Office-Shop

Review conducted January 2012 using 2010 ADA Standards for Accessible Design.

Areas of Non-Compliance & Recommendations

Image 43

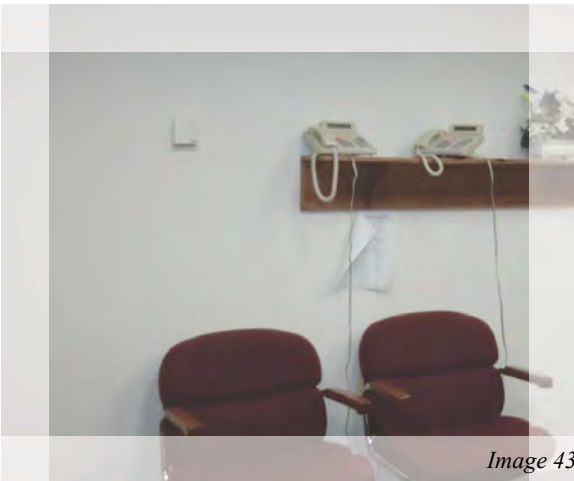
- 0-047 Thermostat control mechanism above allowed reach range and blocked by chair (59-1/2 inches a.f.f.). Controls are measured to highest operating mechanism. A clear floor space of 30 inches by 48 inches is required in front of all elements. [ADA Sections 308] (See Image 43).

Image 67

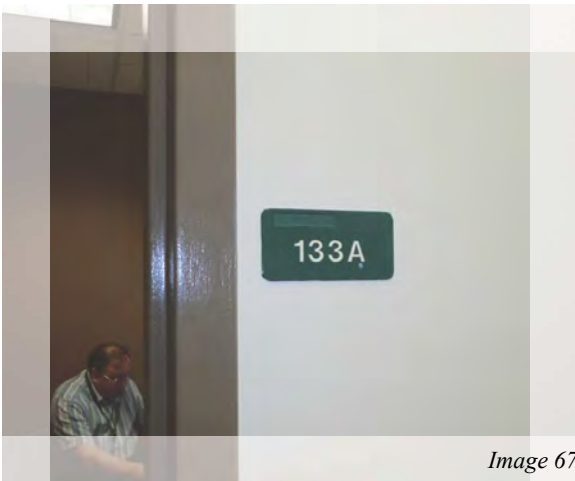
- 0-069 Room identification sign for 133A mounted above allowed height with braille in wrong location (61-1/2 inches to baseline of room number). Tactile characters on signs shall be located between 48 inches and 60 inches above the finished floor measured from the baseline of the tactile characters. Braille shall be positioned below the corresponding text. [ADA Sections 216 and 703] (See Image 67).

Replace sign with one that has compliant positioning of braille tactile characters.

Image 95

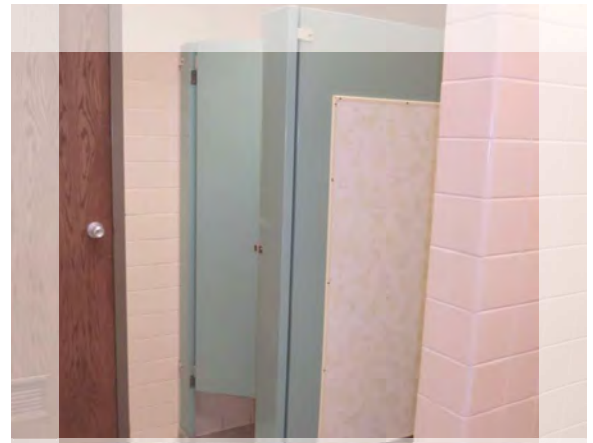
- 0-109 No accessible toilet stall available. Where toilet compartments are provided, at least one toilet compartment shall comply with ADA Design Standards for size, grab bars, toilet seat height and location, toilet paper dispenser, clear floor space, and door requirements. All modifications must meet local administrative authority code requirements. [ADA Section 213.3.1] (See Image 95).

» *Recommendations: Remove stall partitions and wall between urinal and lavatory to create a single-user accessible toilet room meeting all ADA Design Standards.*

Image 100

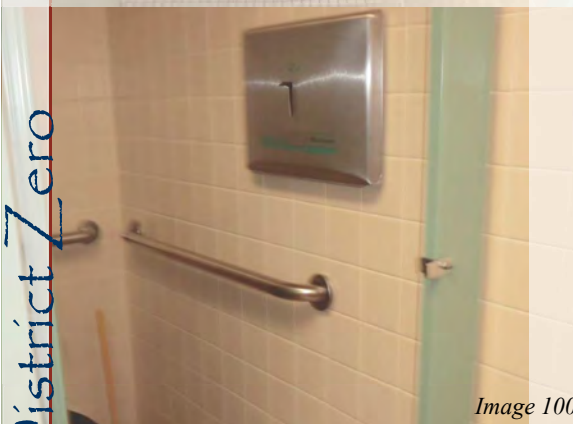
- 0-123 Access to toilet seat cover dispenser above allowed reach range (51-3/4 inches a.f.f.). Where a clear floor space allows an unobstructed approach to an element, the high reach shall be 48 inches maximum, and the low reach shall be 15 inches minimum above the finished floor. [ADA Section 308] (See Image 100). ⚓

Image 113

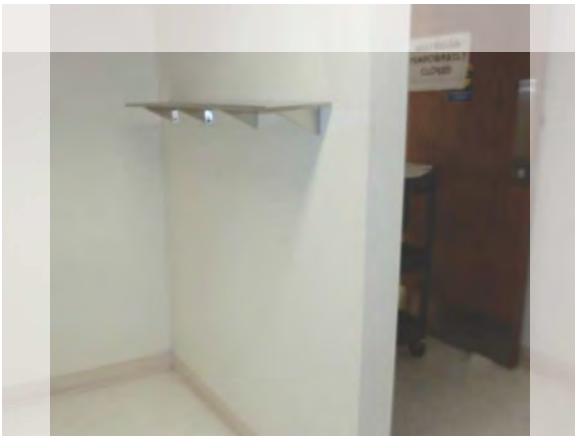
- 0-145 Shelf mounted above allowed height and creates protrusion (54 inches a.f.f.). Shelves shall be located 40 inches minimum and 48 inches maximum above the finished floor. Objects with leading edges more than 27 inches and not more than 80 inches above the finished floor shall not protrude more than 4 inches horizontally within the clear floor space. When a cane is used and the element is not in the detectable range, insufficient time is available for the person to detect the element with the cane before there is body contact. [ADA Sections 307.2 and 603.4] (See Image 113). ⚓ for shelf height.

» *Recommendation: Remove shelf from restroom wall.*
Cost Estimate: \$40.00

Image 121

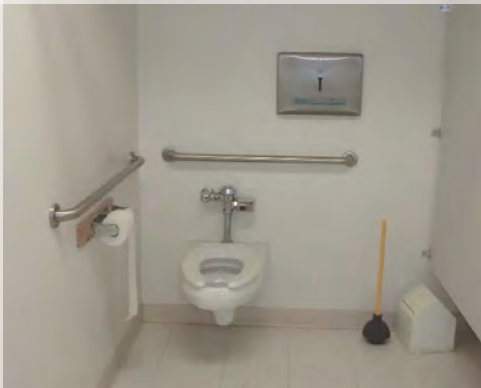
- 0-155 Grab bars mounted too high above finished floor (36-7/8 inches a.f.f. - rear/ 36-5/8 inches a.f.f. - side). [ADA Section 609.4] (See Image 121).

» *Recommendation: Reinstall grab bars so that tops of gripping surfaces are between 33 and 36 inches above finished floor.*

Image 122

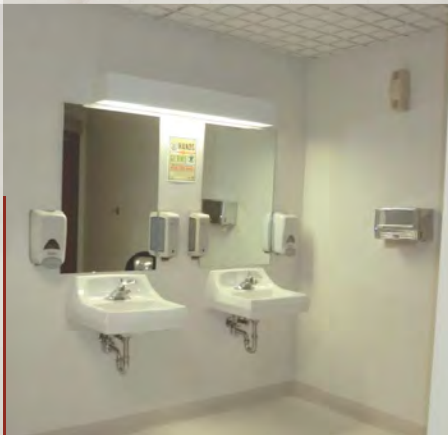
- 0-156 No pipe protection provided under lavatory. Water supply and drain pipes under lavatories must be insulated or otherwise configured to protect against contact. [ADA Section 606.5] (See Image 122).

Image 123

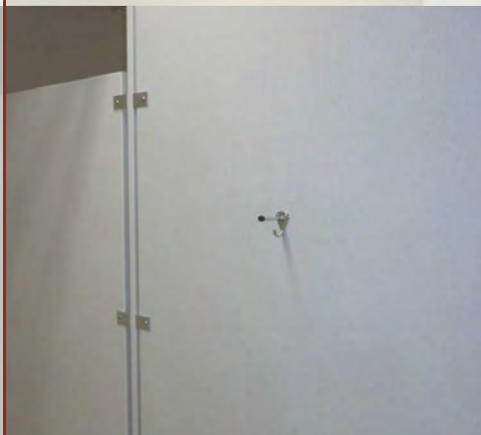
- 0-158 Coat hook on wall of toilet compartment above allowed reach range (54-1/4 inches a.f.f.). [ADA Sections 308 and 604.8.3] (See Image 123). ⚓

» *Recommendation: Add a second coat hook at a height of 48 inches above finished floor.*

Image 36

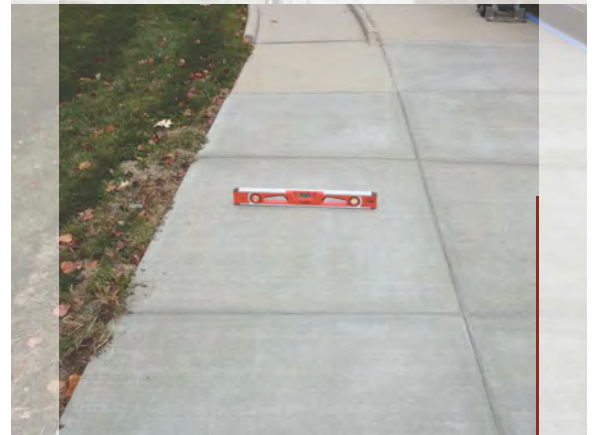
- 0-170 Change in level at entrance to westernmost curved walkway leading to public entrance of Building 00201 greater than allowed by ADA design standards. Changes in level of 1/4 inch high maximum shall be permitted to be vertical. Changes in level between 1/4 inch high minimum and 1/2 inch high maximum shall be beveled with a slope not steeper than 1:2. [ADA Section 303] (See Image 36).
